**TO:** Olivia Whittaker, P.E., CFM

**FROM:** Jeremy D. Dixon, P.E., CFM, Maria C. Velazquez, E.I.T., CFM

**SUBJECT:** FP23-04 – 6050 Belt Line 3<sup>rd</sup> Submittal

**PROJECT:** DWU22105 - Dallas Floodplain Reviews

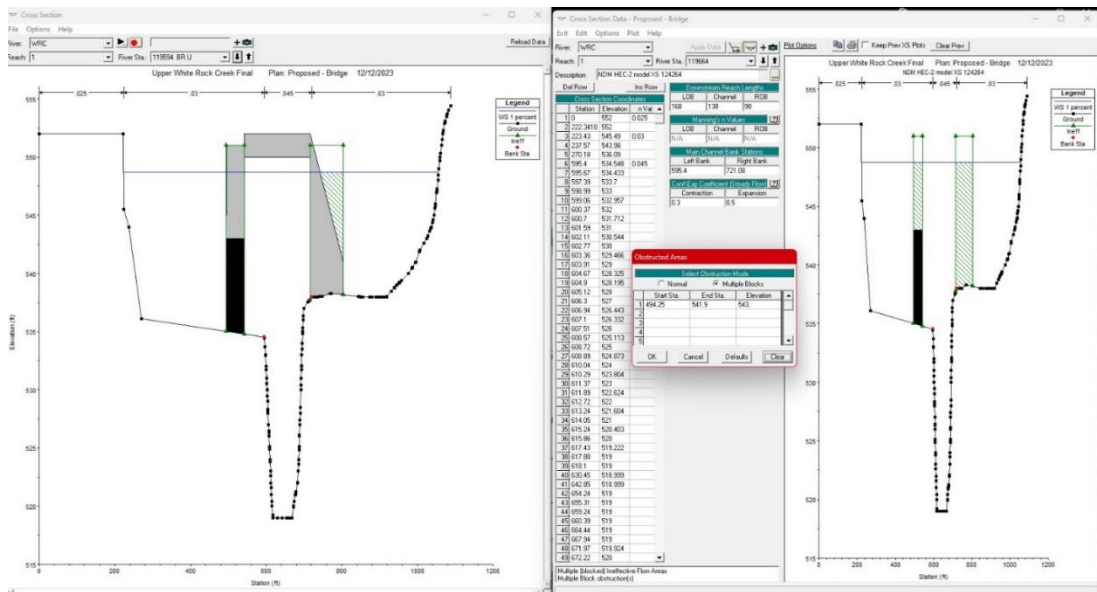
- In the proposed conditions model for the scenario without a bridge, cross section 119591 (referenced below) was eliminated. This was done to ensure that there were no negative alterations between the revised existing and proposed conditions results, in the event that the proposed grading for the pedestrian bridge is excluded. This modeling preference did not alter the final conclusion.
